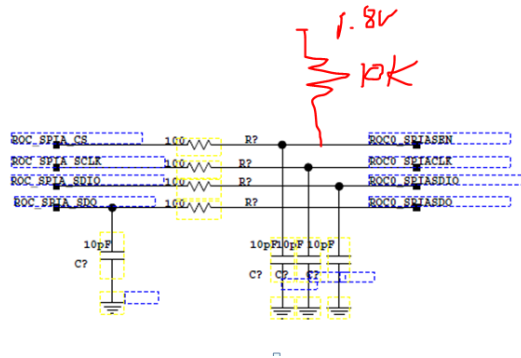
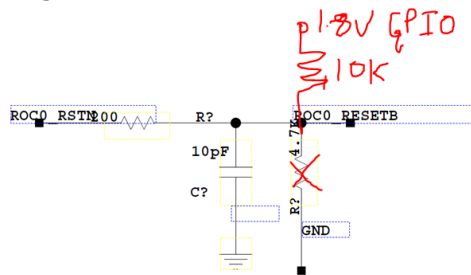
1. SPISEN does not have pull up resistors. Add pull up resistor to GPIO 1.8V supply for SPIASEN, SPIBSEN and SPI2SEN

2. RESETN does not have pull up resistors. Add pull up resistor to GPIO 1.8V supply for RESETN and not ground

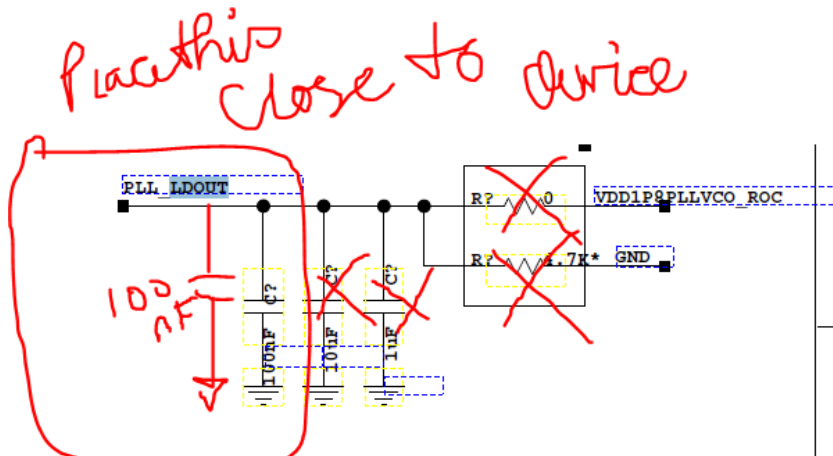
3. Replace with 2 numbers 100nF close to device. Remove all other components.

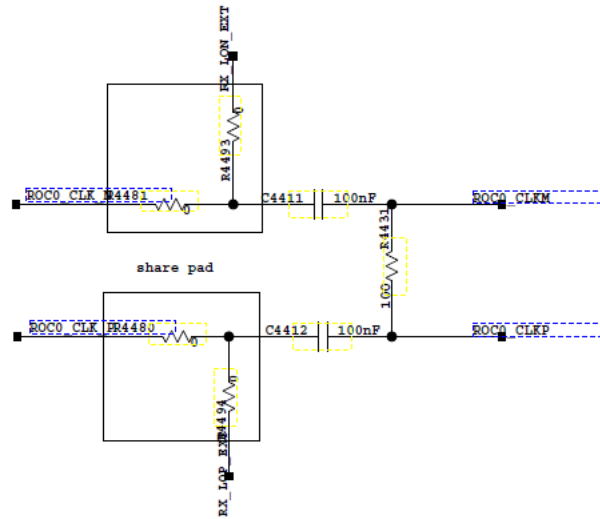
4. REFCLK has internal termination. 100 ohms below can be removed.

5. Can customer do pulse mode or they want sysref in continuous mode?

a)

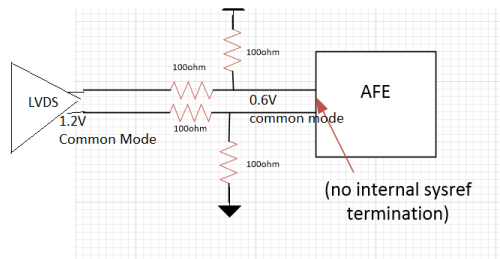
For pulse mode, replace 100nF with 100 ohm , Replace R4412&R4412 with 100hm and DNI R4415. Like below configuration

b)

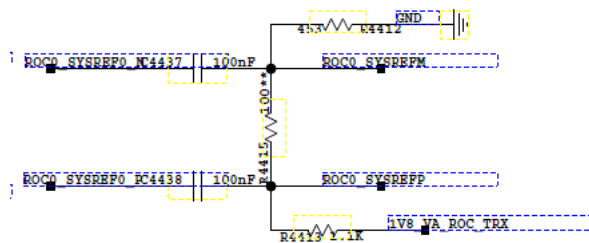
For sysref continuous mode, DNI resistors R4412, R4415 and R4413
